CRANDON PROJECT

October 16, 1986

This letter is to transmit to the Department of Natural Resources revisions to the WPDES Application dated December 1985 and revised May 1986. The attached revisions (five copies) are a result of recent discussions with the Department relating to wastewater characteristics, excess discharge lagoon liner system, and contingency mitigation plans. In addition, the attached drawings reflect minor changes in the plot plan.

REVISED  
WISCONSIN POLLUTANT DISCHARGE ELIMINATION SYSTEM  
WASTEWATER DISCHARGE PERMIT APPLICATION

**FIGURE 002-4**

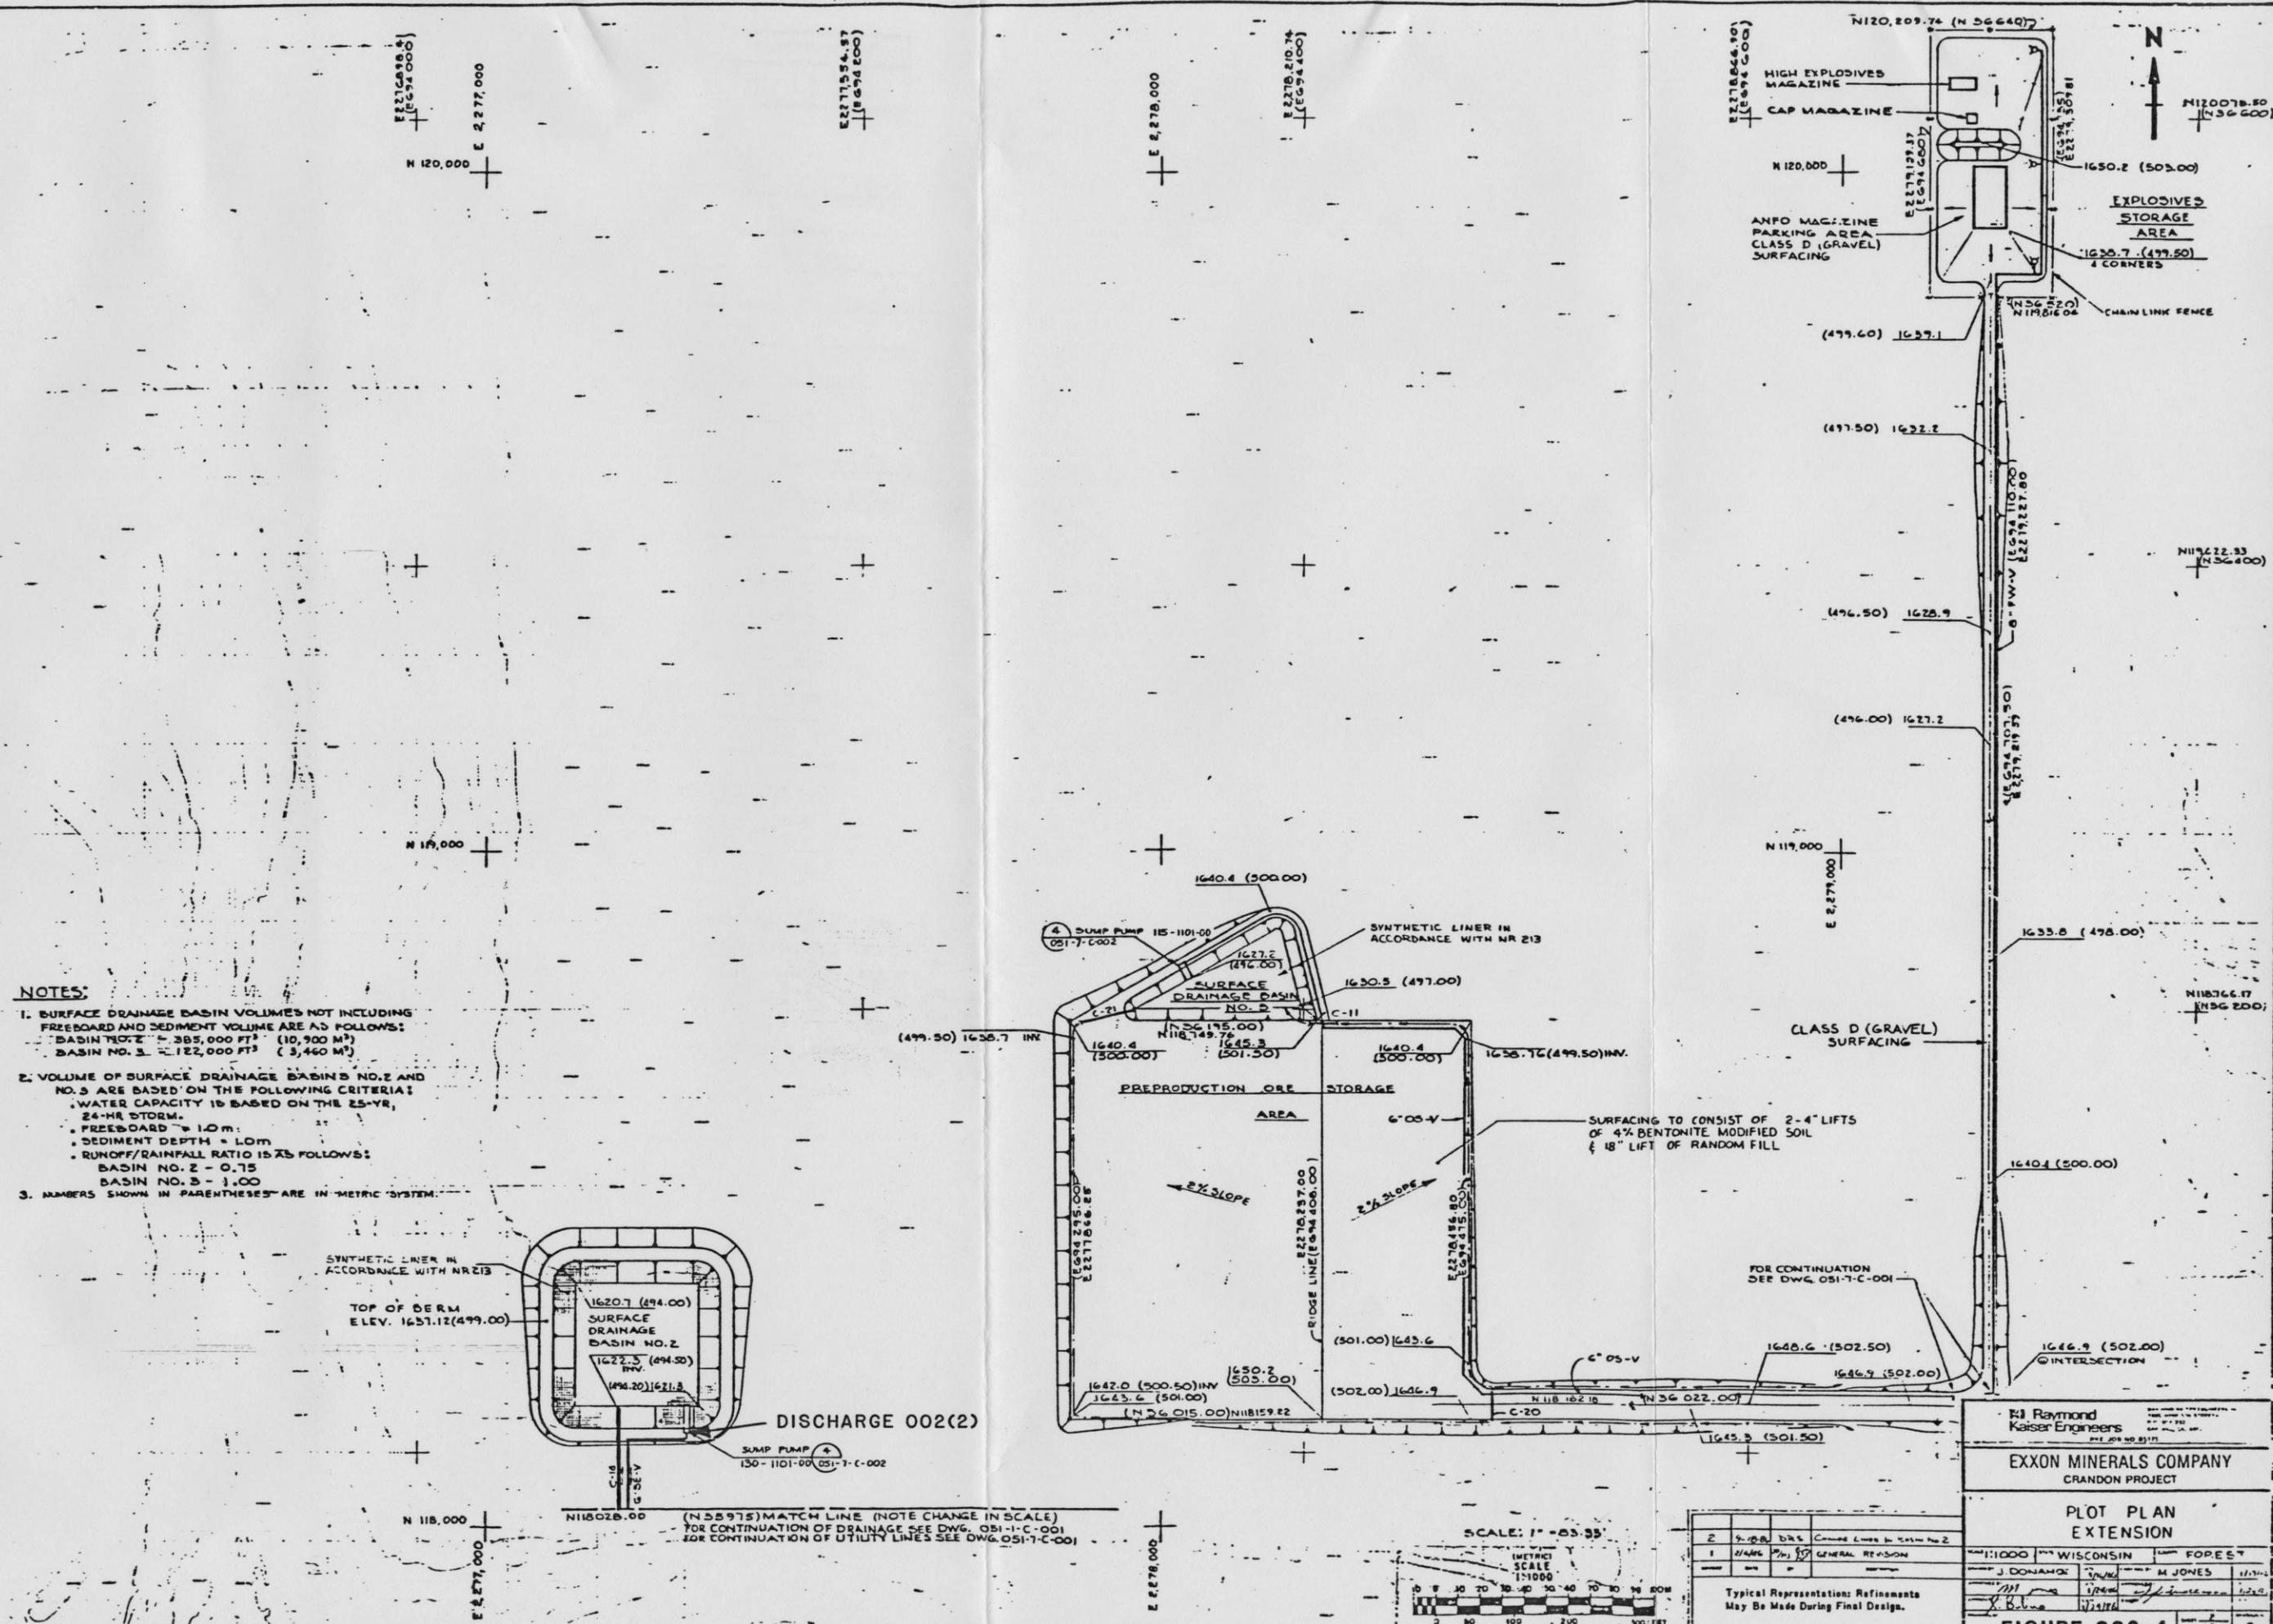
- Figure 002-3 "Grading and Drainage Plan"
- Figure 002-4 "Plot Plan Extension"

**FIGURE 004-2**

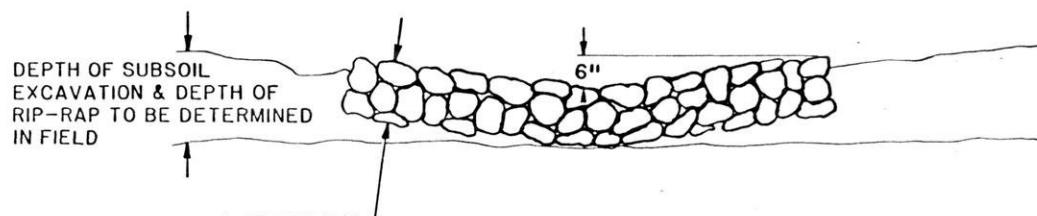
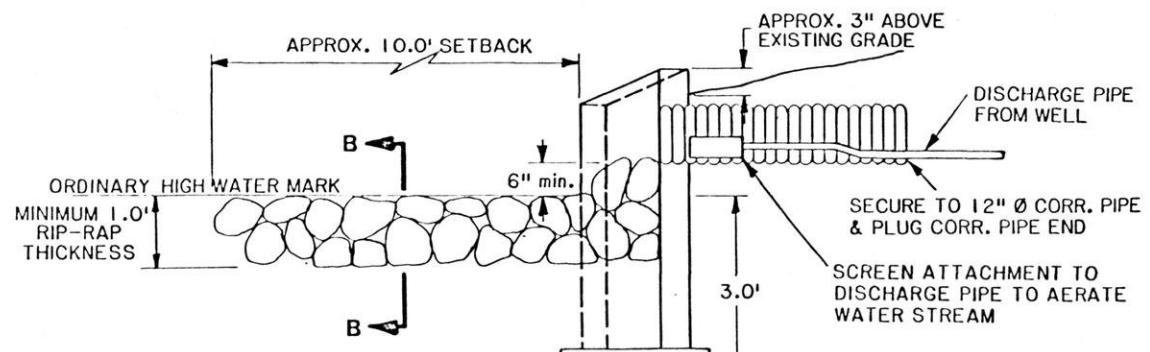
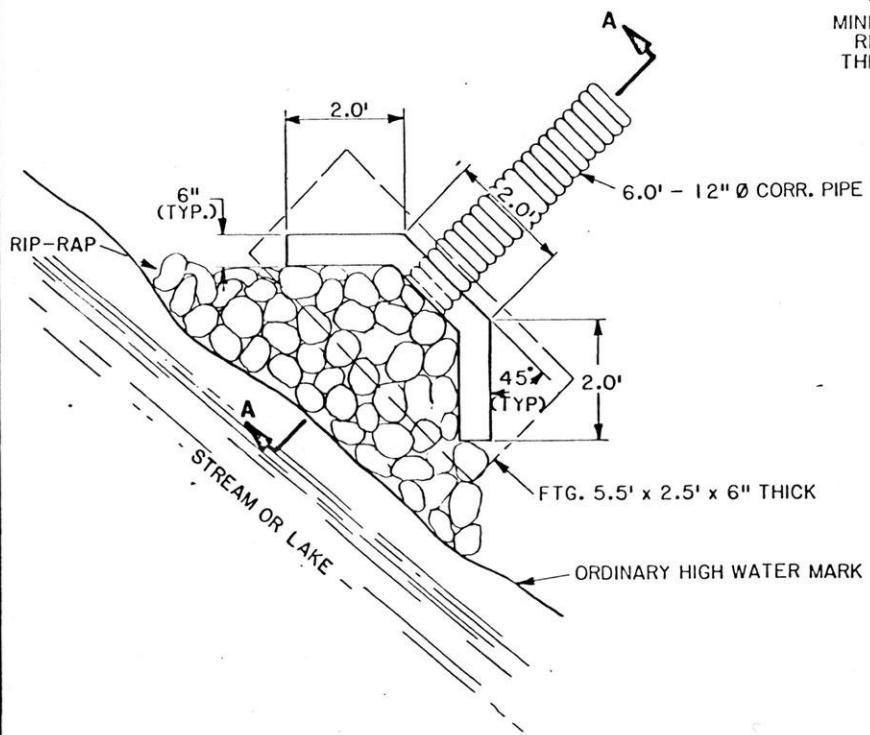
- Page II-4. Item 15b. Waste Abatement Codes. Change to the proper spelling of the word "described."
- Item 202b. Pages II-8a through II-8j.
- Figure 004-2 "Typical Discharge Structure for Streams, Springs and Lakes

SKUNK LAKE  
WATER SUPPLEMENT SYSTEM

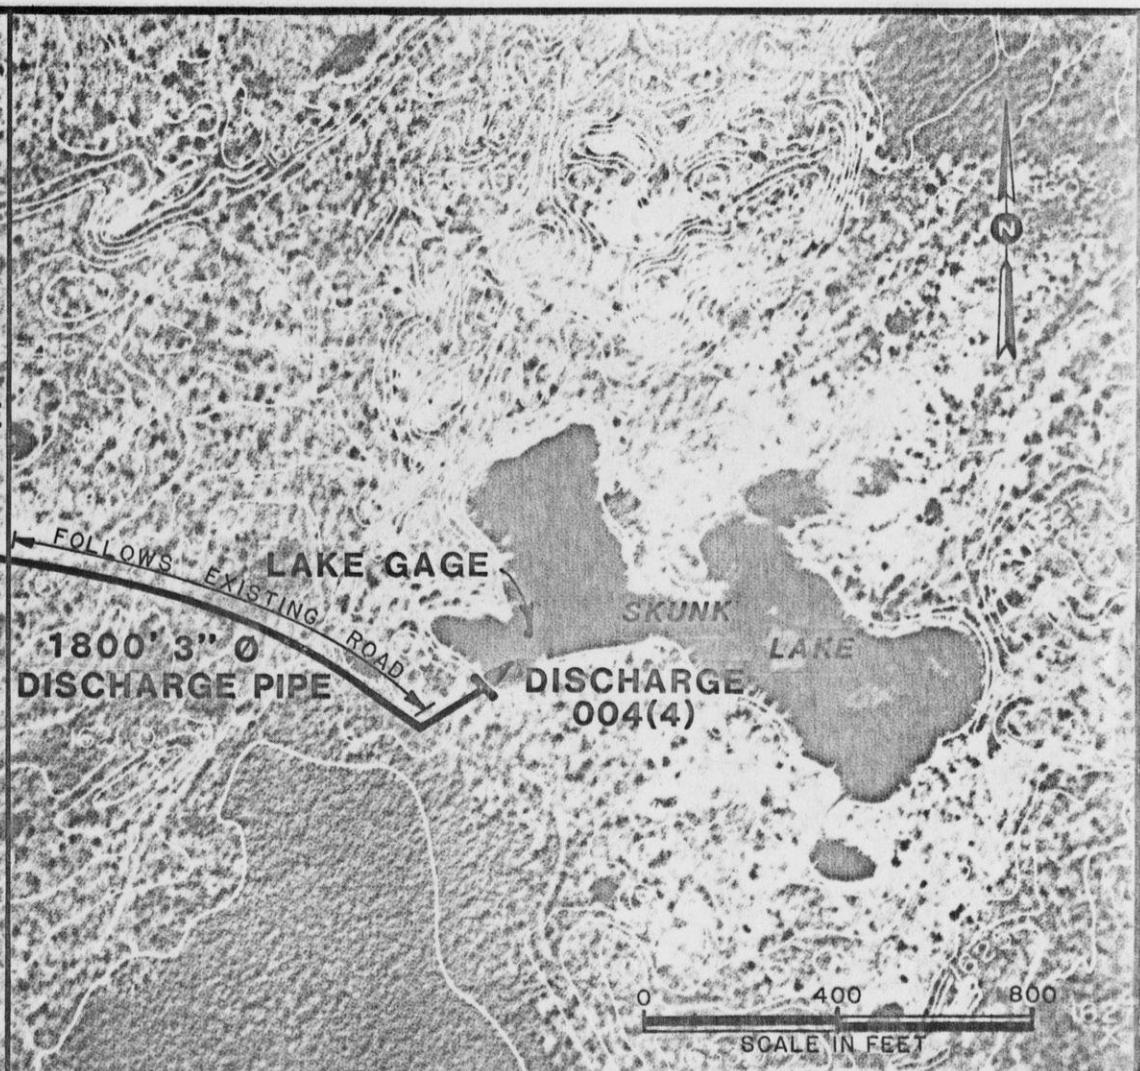
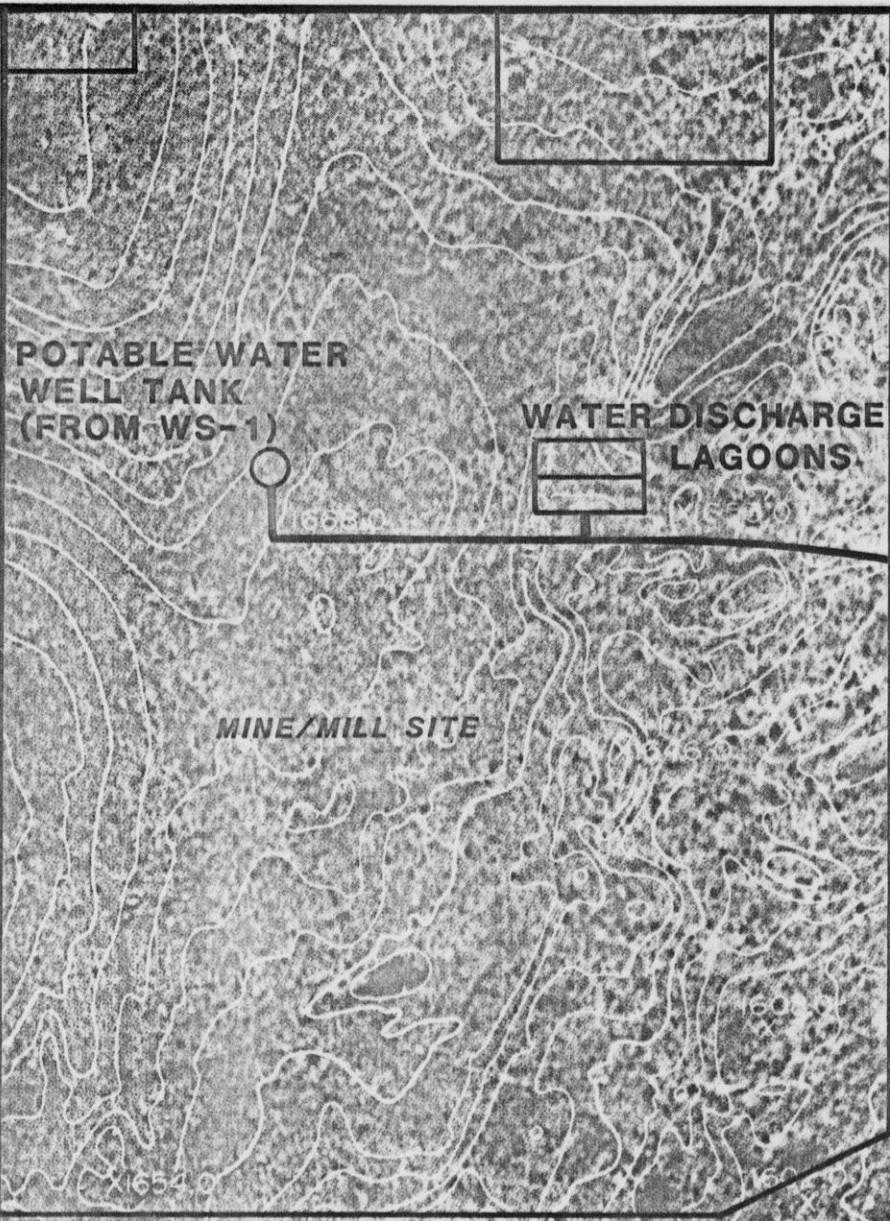
The discharge to Skunk Lake [004(4)] will be based on lake level. The supplement will range from 2 to 115 gpm depending on lake level. The locations of the pipeline and the discharge structure are shown in Figure 004-6. The supplement will consist of ground water from the mine ground water intercept system or ground water from the potable water tank (water from well WS-1) blended with treated mine water to meet the DNR effluent standards for Skunk Lake.

The supplement will range from 45 to 150 gpm depending on lake level. The locations of the pipeline and the discharge structure are shown in Figure 004-6. The supplement will consist of ground water from the mine ground water intercept system or ground water from the potable water tank (water from well WS-1) blended with treated mine water to meet the DNR effluent standards for Skunk Lake.
